SERVICE BULLETIN

PURPOSE : INFORMATION	ISSUE NO. : MSB-12E00-004	DATE : 2012-07-13
SUBJECT : INFORMATION ON 2013.5MY i-MiEV		<Destination/Model> (EUR) i-MIEV(HA3W/HA3V) <M/Y> 13.5
GROUP : GENERAL

This Service Bulletin contains the information about the 2013.5MY i-MiEV Workshop Manual

REAR FRAME

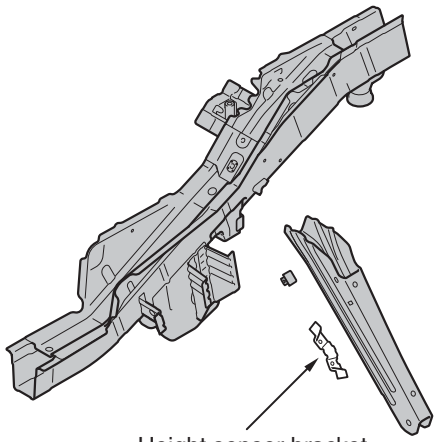
Due to the addition of the headlamp automatic levelling system, the height sensor bracket has been added.
